Project:	Lower Berse Farm, Ruthin Road, Wrexham	Scheme No:	13840
Subject:	Response to LLFA Comments	Revision:	01
Client:	Redrow Homes Ltd	Date:	23/06/2026
Doc Ref:	13840-Response to LLFA Comments - 03		
Author:	Aled Williams BSc (Hons) MCIWEM C.WEM

Waterco have received additional comments dated 1st May 2026 from Pell Frischmann acting as Lead Local Flood Authority (LLFA) for Wrexham County Borough Council in relation to an outline planning application (P2024/1466) for 1450 dwellings and provision of land for a Primary School at Lower Berse Farm, Ruthin Road, Wrexham, LL14 4HP.

Project	Lower Berse Farm
Document Title	P/2023/0593 - Lower Berse Farm Planning Response.
Document Reference	P_2023_593-PEF-HDG-XX-TN-D-0001
Revision Reference	P02
Date	01/05//26

TECHNICAL NOTE – FLOOD RISK & DRAINAGE COMMENTS

EXISTING CULVERT EXTENSION & PROPOSED
BOX CULVERT UNDER HIGHWAY LAYOUT WITH
SECTION

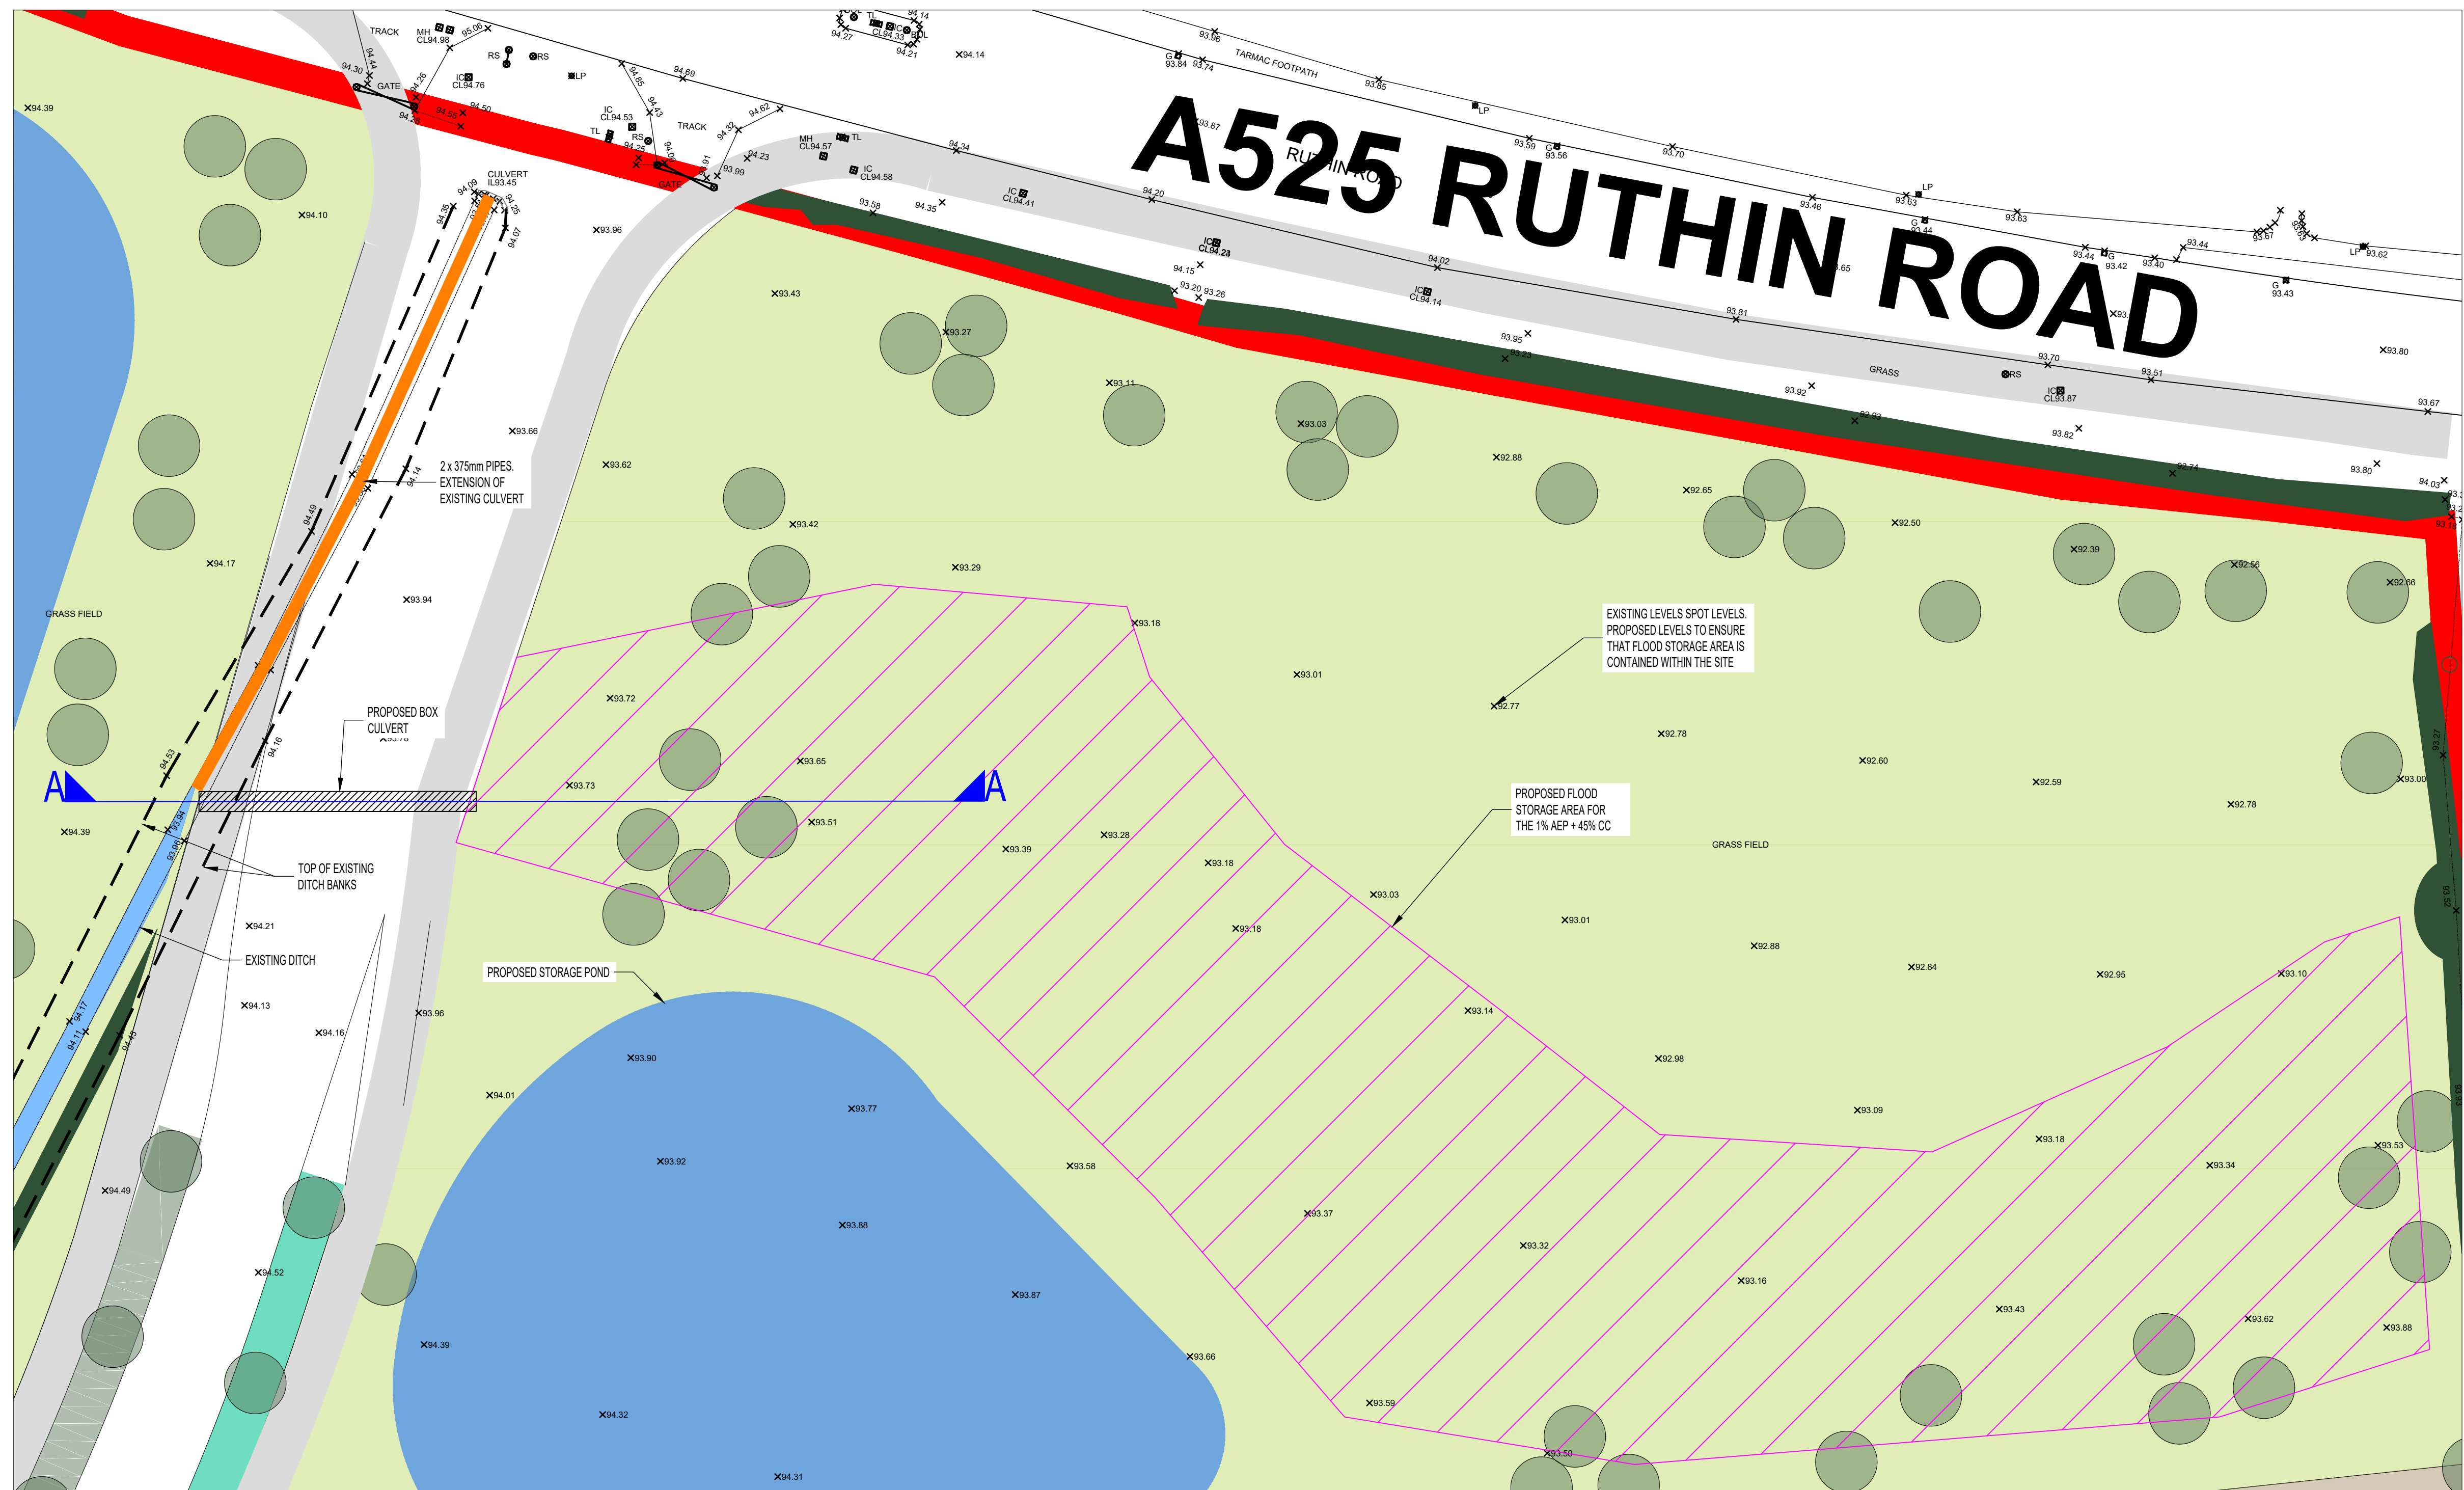
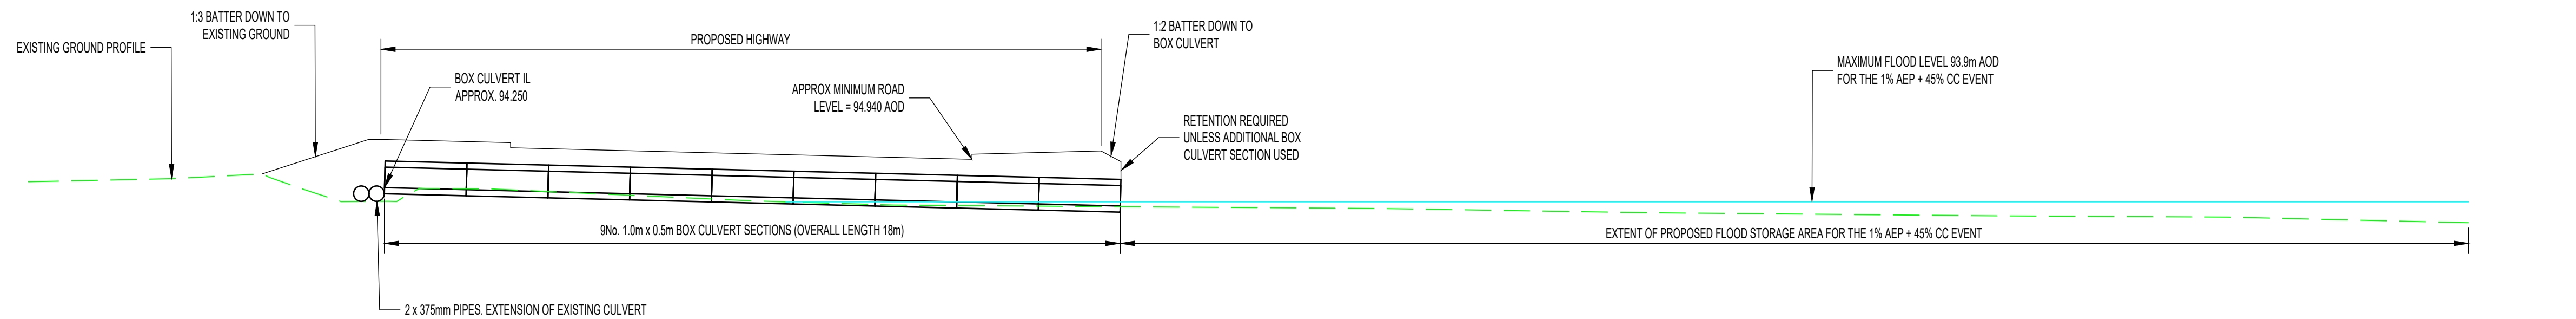
- 5) Further details of the flood storage area in the north-eastern extent of the site are required showing levels. Further details of the proposed access road level changes and culverting are required (at the proposed site access off Ruthin Road).

- We require more details of the proposed culverting at the main access point. Again, not detailed design level, but a detailed sketch of what is envisaged in this area is required

A sketch plan of the proposed access road culverting arrangement is provided as Appendix D. The existing Ruthin Road culvert will be extended southward into the site beneath the access road. A flood relief box culvert will be placed beneath the access road to provide a flow pathway for any out of channel flows to reach the flood storage area east of the access road (replicating existing flow paths).

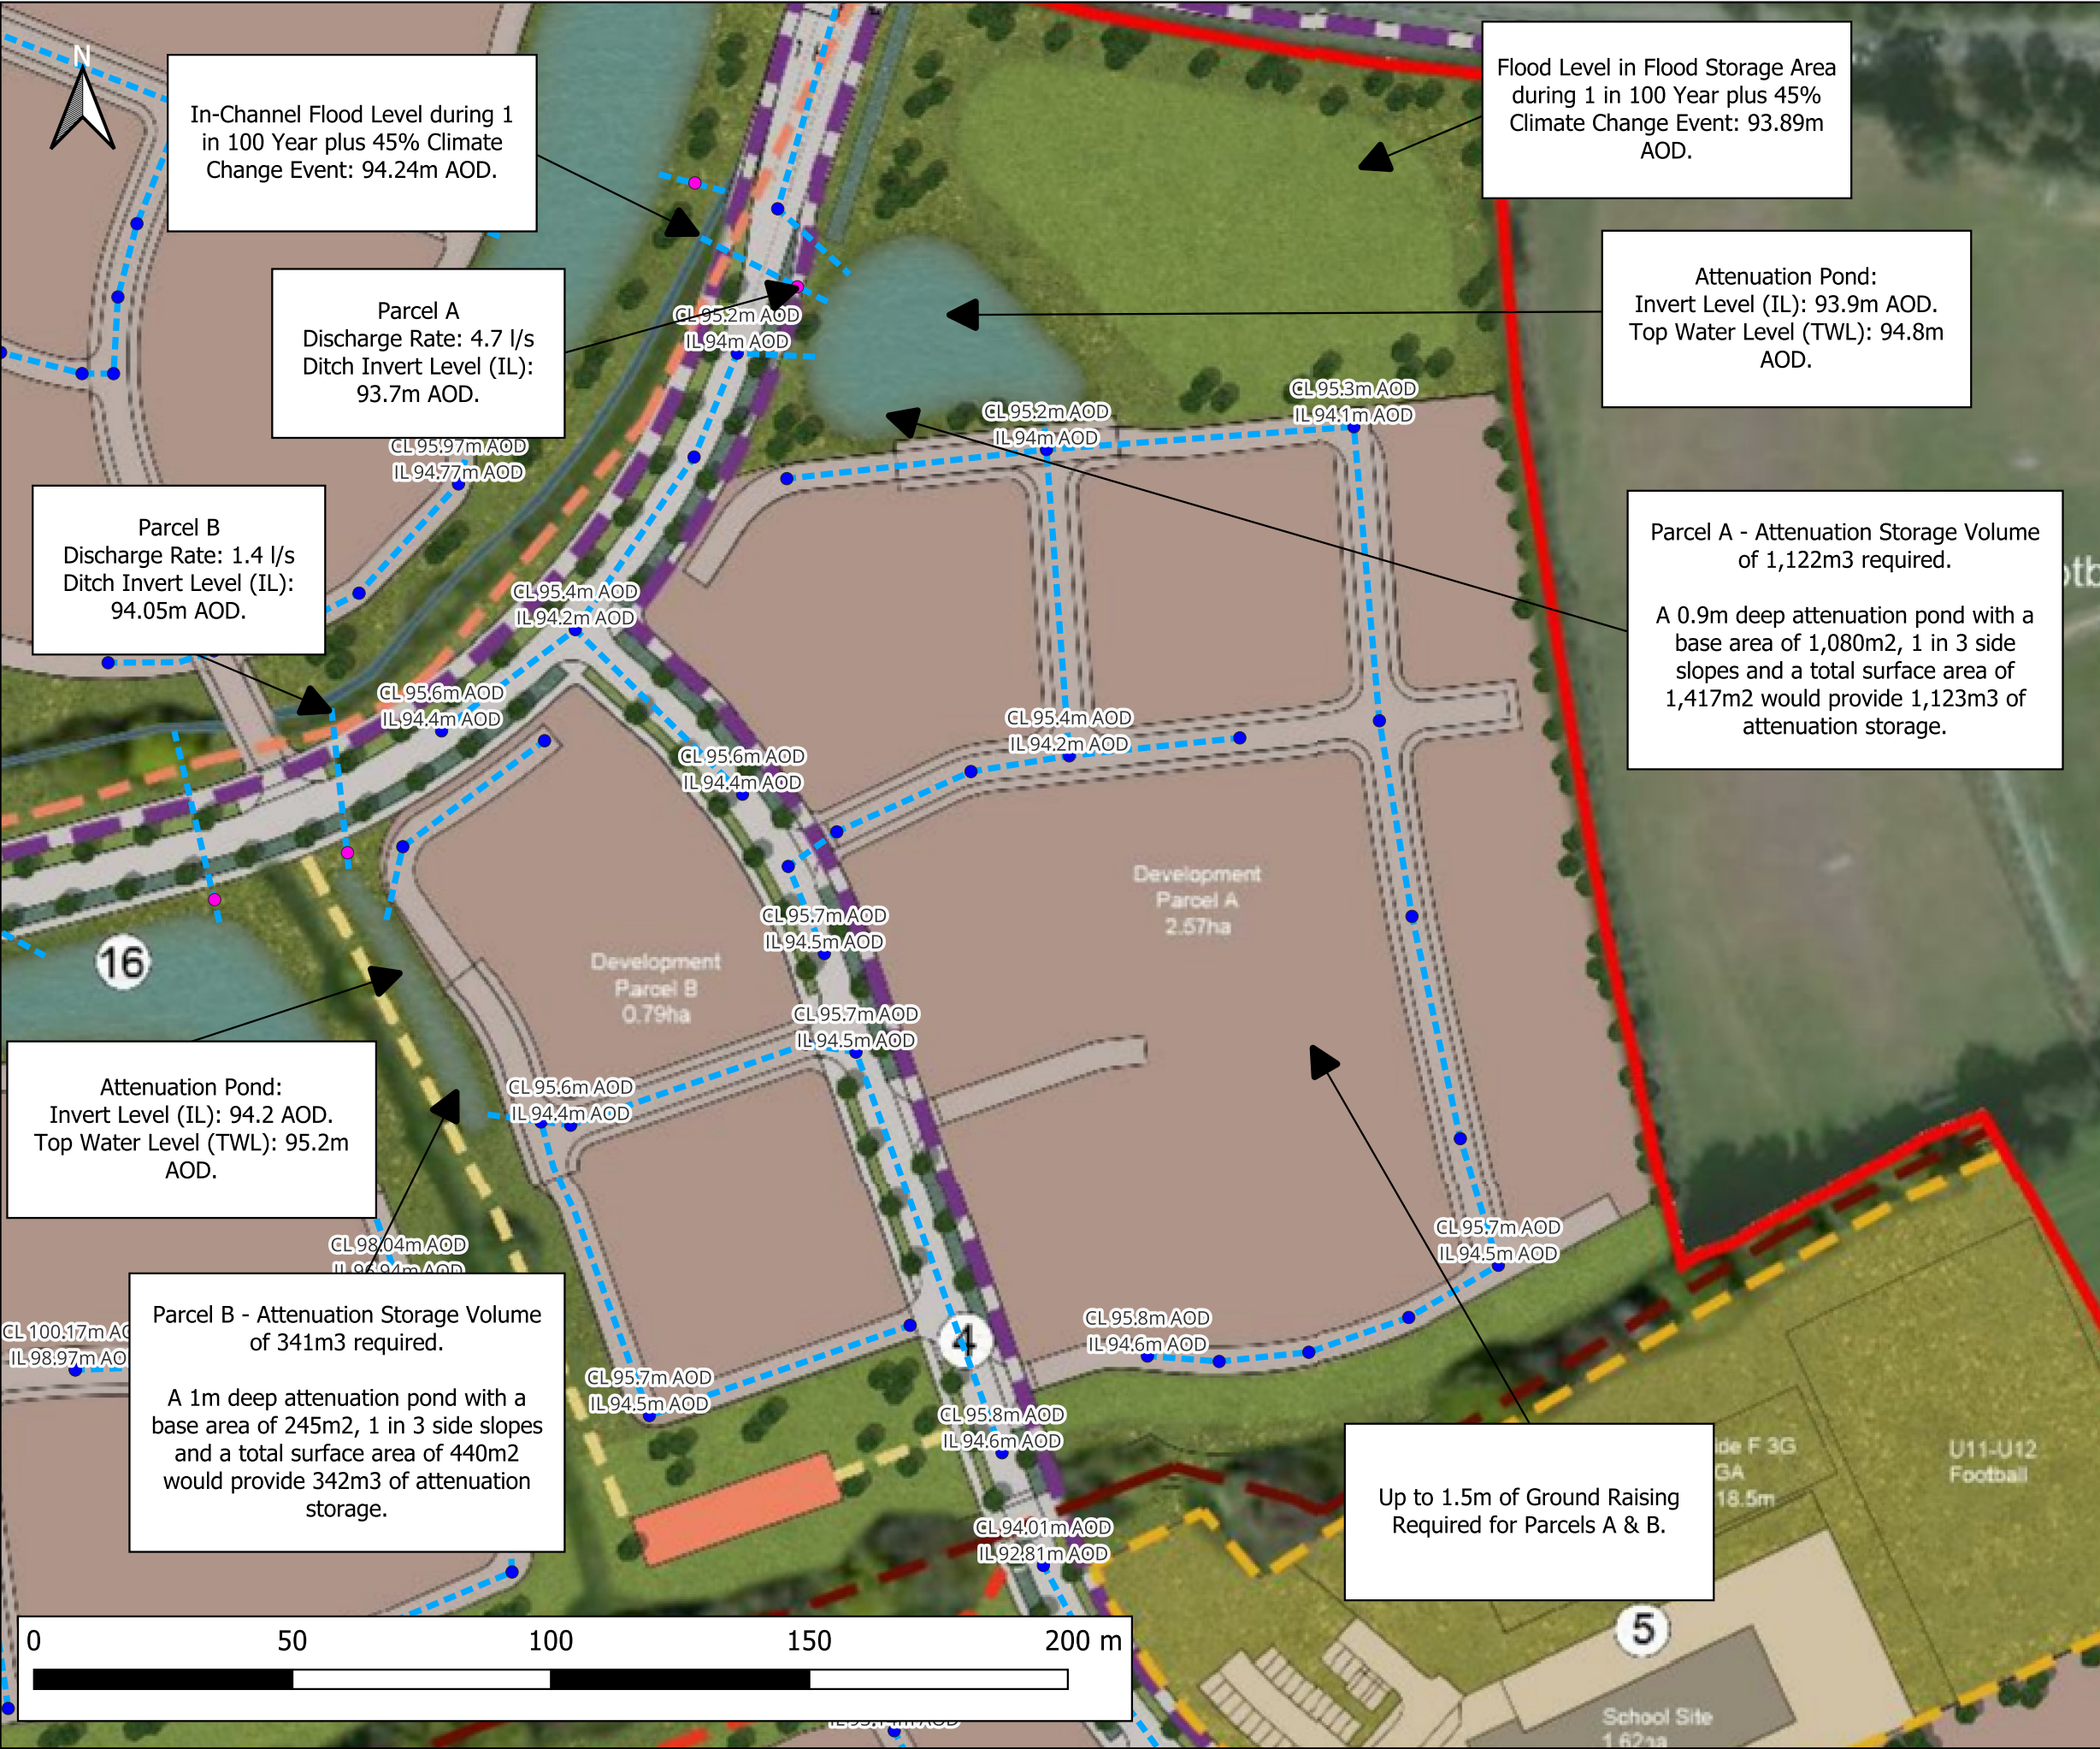
- 6) Further details of the drainage arrangements / levels on the main distributor / spine roads are required.

- The Concept Drainage Sketch provides many of the level information requested. To close this comment please provide some indicative levels on the main distributor roads/spine roads. We do not require detailed design level of information, but we require sufficient additional levels in the same manner as the key points shown on the parcels.

- 6) The Concept Drainage Sketch plans have been updated to show the drainage and indicative levels of the main spine road through the site. The Concept Drainage Sketches are provided as Appendix E.
